## ***TECHNICAL BULLETIN***

### ***ADDITIONAL WELDING ON FOOTRING OF CYLINDER***

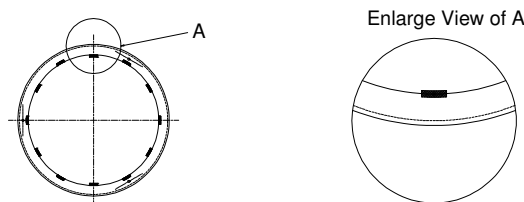
We have had two (2) cylinders returned to the Factory due to stress failure of welds on the footing.

Following an investigation, it was established that the retaining cylinder straps were found to be loose which allowed the cylinder to vibrate and move within the cylinder bracket.

1. Care must be taken when fitting the cylinder support bracket that the retaining straps are horizontal and tight.
2. At the scheduled periodic inspection it is essential that the “Check all foam agent storage cylinder brackets and vibration eliminator mounts are secure and tight”.  
(Item 1.1B Periodic Inspection)
3. Properly tightened retaining straps are the correct and approved method to Ensure such damage does not occur.

### **Welding Detail**

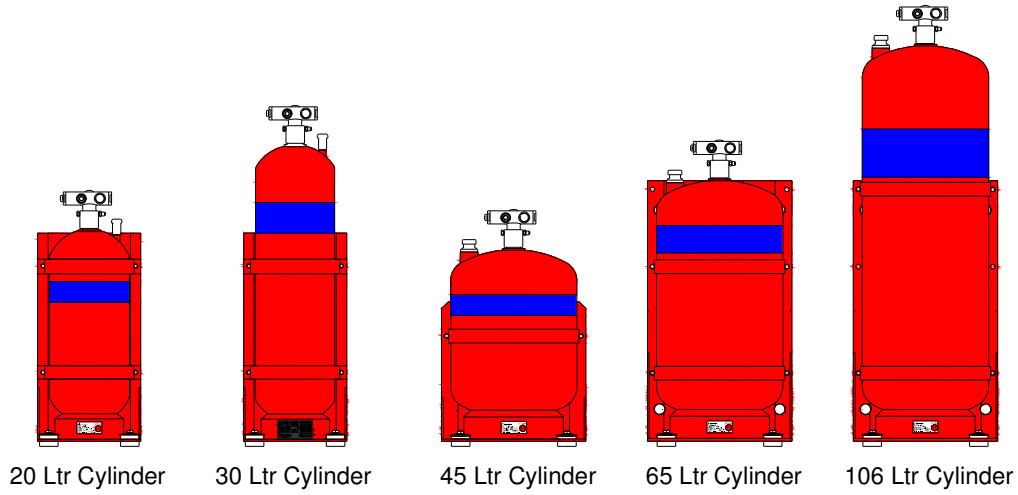
ETI in its response, starting in June 2012, has increased the welds in this area from six to twelve to further strengthen the cylinder base.

- Each base ring must be welded with a min. of 12 welds.
- Welding place is six on the internal base ring, and six on the outside of the ring Staggered

Welds placement has been increased from six on the internal base ring and six on the outside of the base ring staggered evenly, this action commenced June 15, 2012.
